GSGNY Bid Addendum Two (2)

Date: 8 July 2022

Project Name: Girl Scouts of Greater New York (GSGNY)

Project Number: 2005

1 FIRST FLOOR CONSTRUCTION PLAN
SCALE: 1/8"=1'-0"

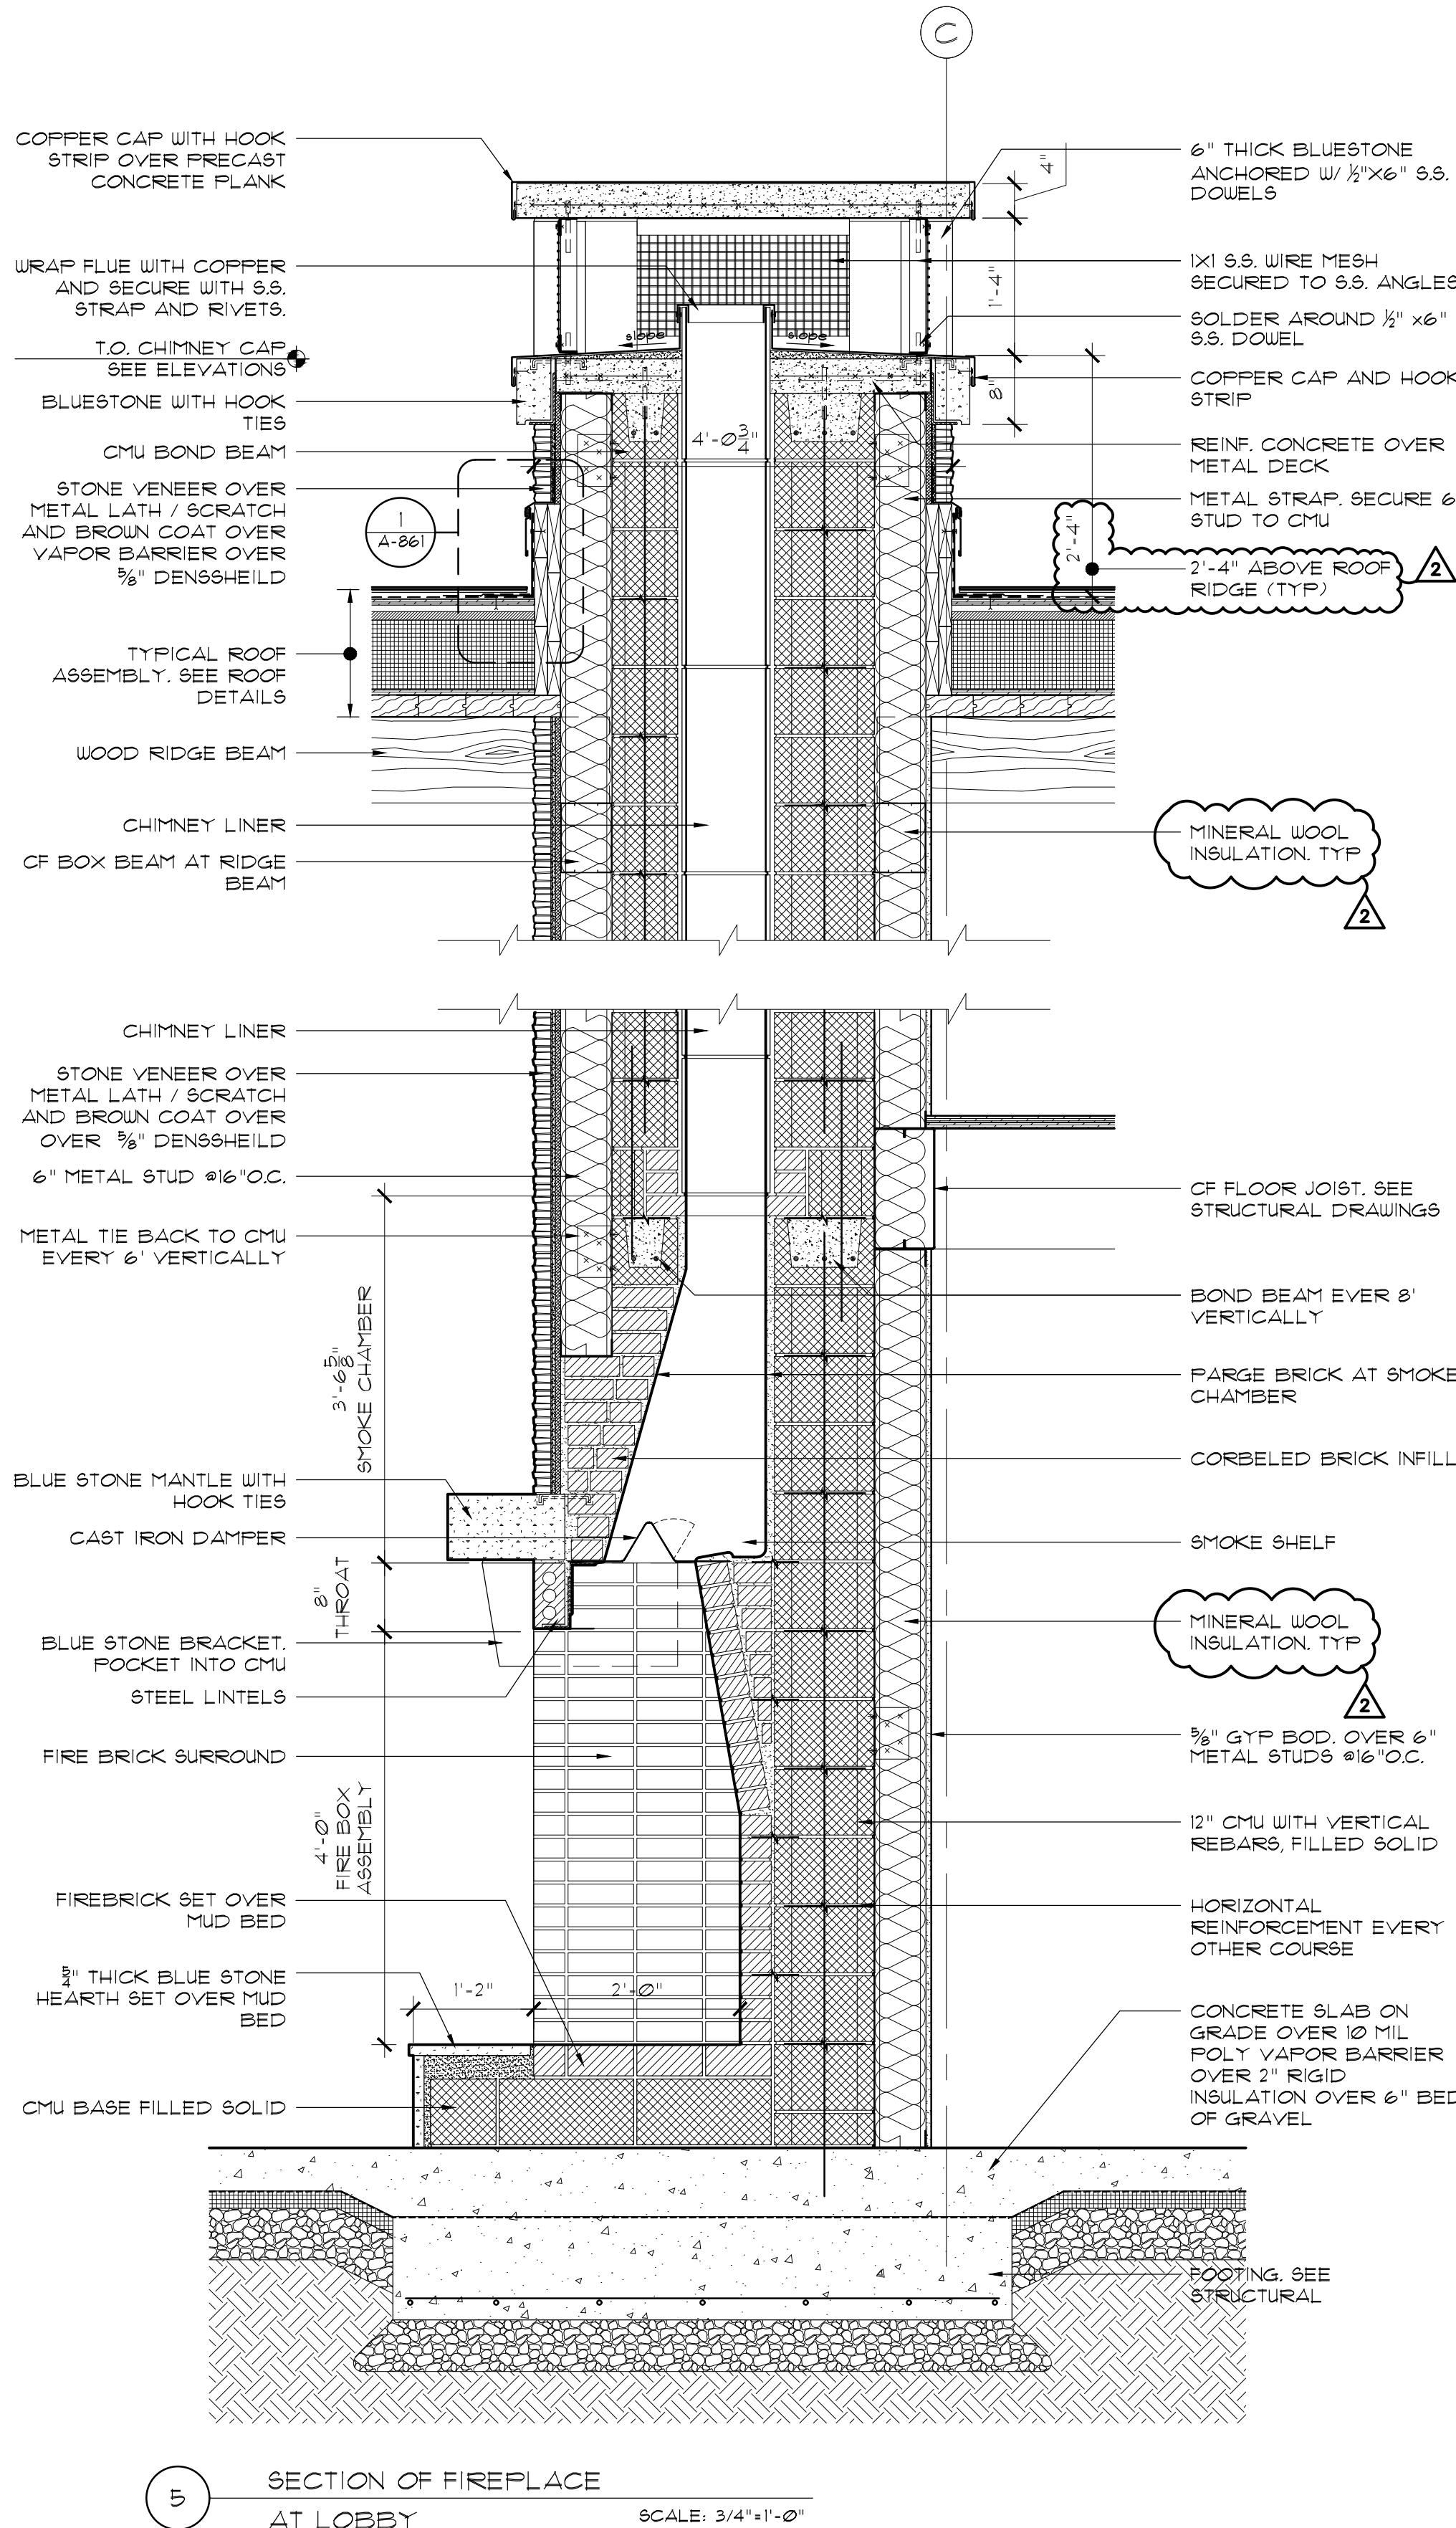
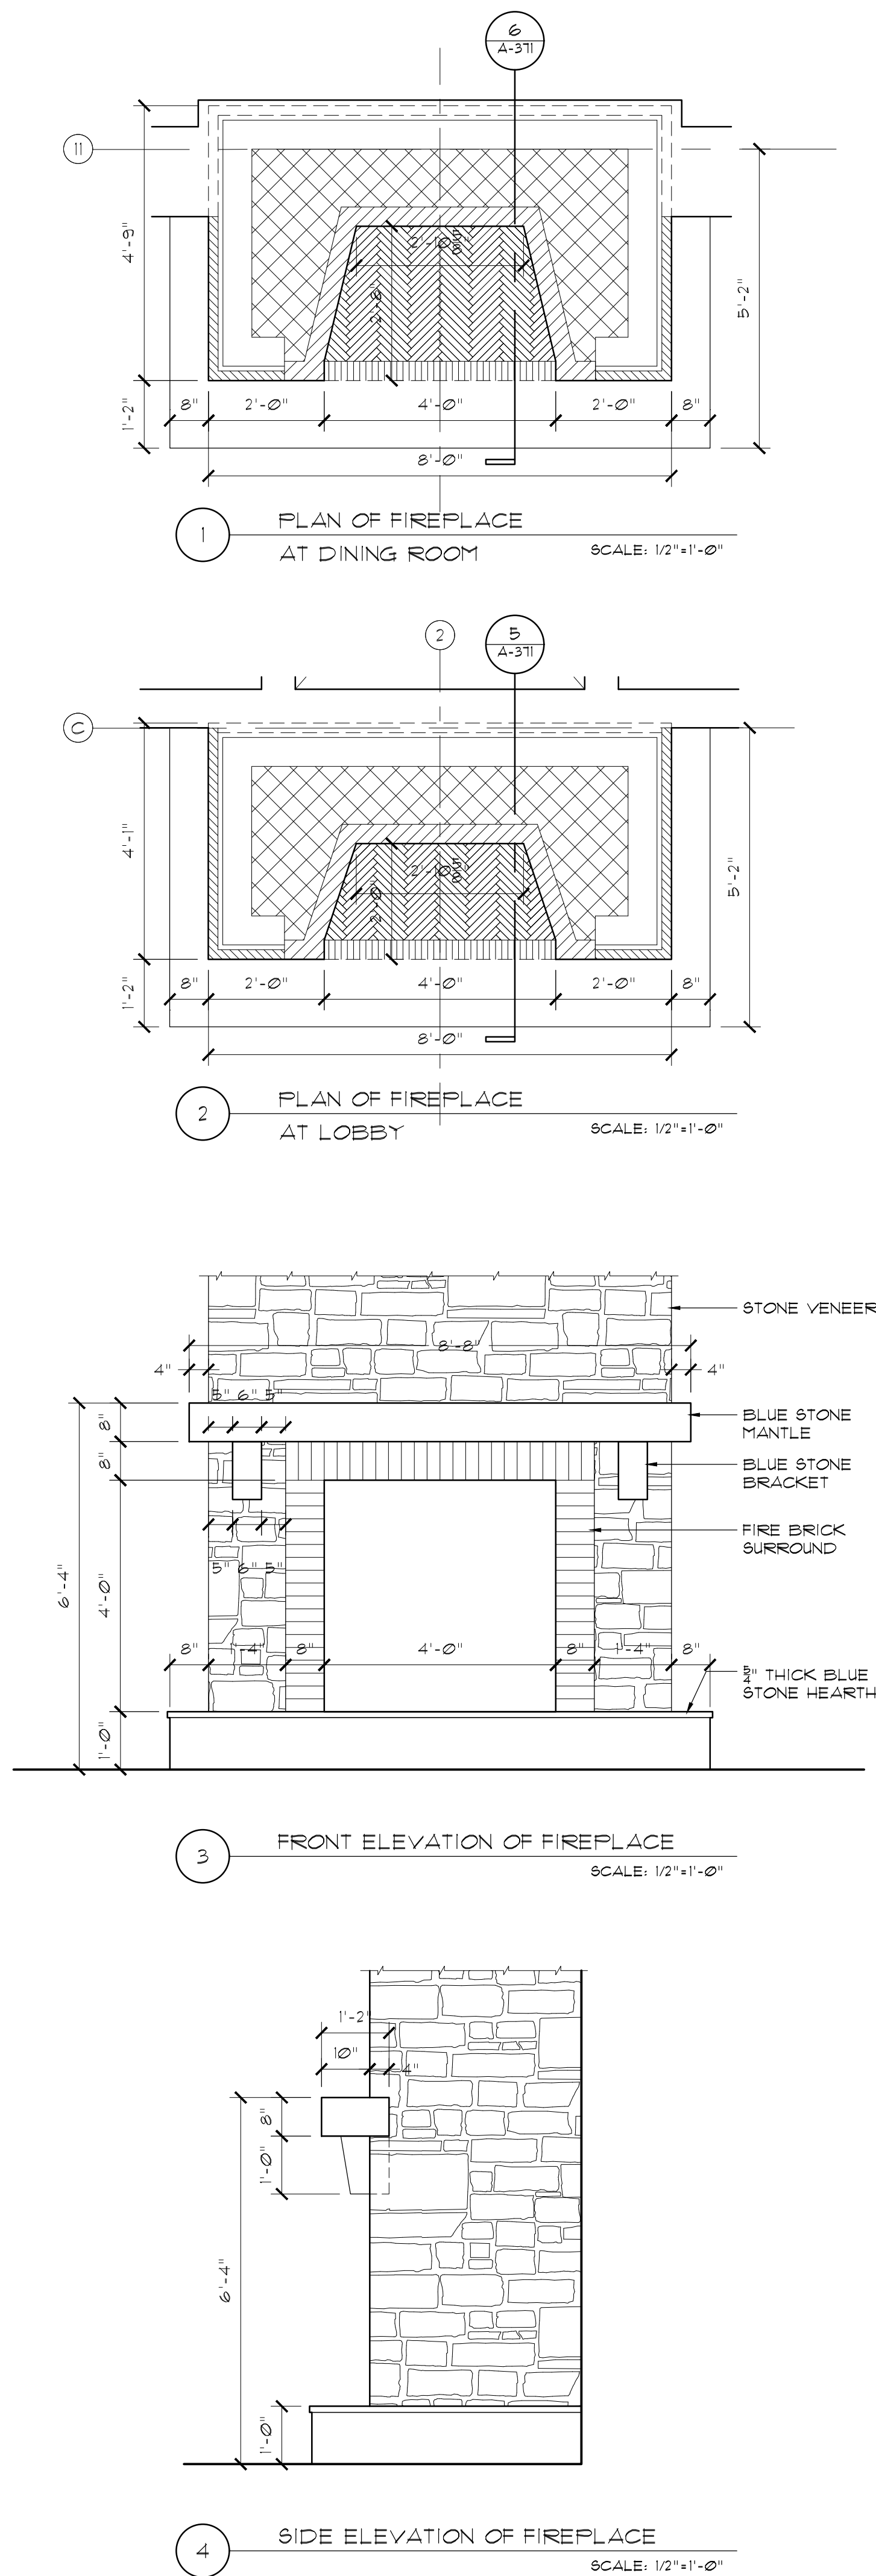
- A-101 First Floor Construction Plan
 - Wall type clarification at stair – wall type 2
- A-360 Enlarged Details
 - Clarification of precast post base size
 - Clarification of precast sills at exterior doors
- A-371 Fireplace Details
 - Clarification that insulation at fireplace is to be mineral wool type
 - Clarification of chimney height
- A-900 Door Schedule
 - Revision to door type D2 to HM with vision lite
 - Clarification of aluminum storefront door type (see below for spec clarification)
 - Clarification to Door SF3 as thicker 2.25: Insulpour door (see below for spec clarification)
- A-901 Window Schedule
 - Added L-7 louver on north side
 - Clarification to glazing key (see below for spec clarification)
